1 Change operation of recording / playback stop

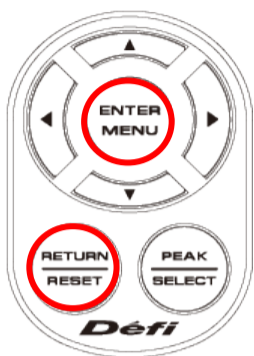
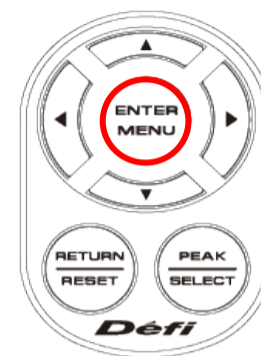
Revised the operation for stopping log data recording (REC). Unintended REC stop is less likely to occur. The operation for stopping log data playback (PLAY) is changed to the same operation, too.

● Touch panel operation (DF15901 and DF15902)

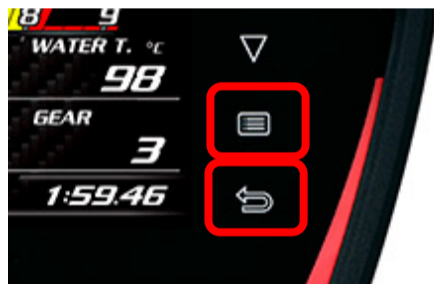
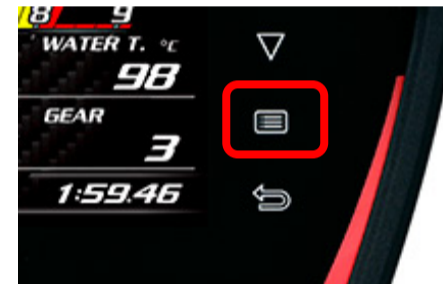
Button to operate to stop recording / playback of log data
(After the update, REC and PLAY will stop with "Call operation of menu.")

- ① Touch MENU button
 - or
 - ② Touch RETURN button
- Previous version operation

- ① Touch MENU button
- Ver. 5.2 update version operation
